# Technical Service Bulletin

<b>Topic</b>	Sporadic entries - Nano connector contact testing
<b>Market area</b>	Bentley: worldwide (2WBE),China 796 VW Import Comp. Ltd (Vico), Beijing (6796)
<b>Brand</b>	Bentley
<b>Transaction No.</b>	2080901/1
<b>Level</b>	EH
<b>Status</b>	Released for publishing
<b>Release date</b>	Feb 11, 2026

Figure 1. Nano type contact example

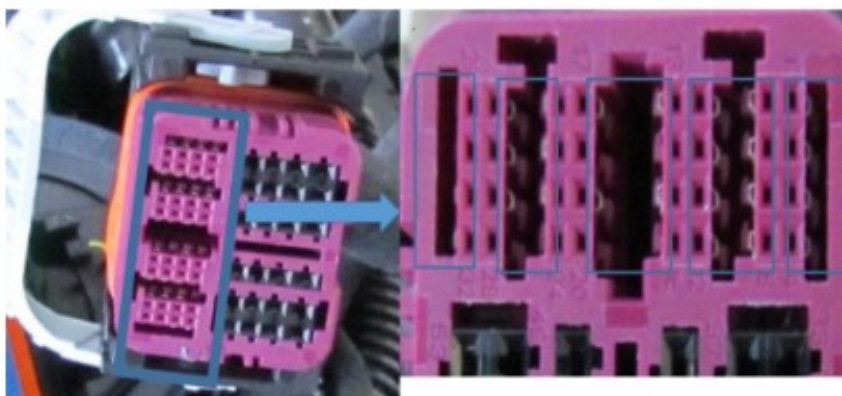
Mechanically check the contacts on the affected control unit plug. Nano type terminals are used in modules such as J234, J623 and J949 (see images supplied).
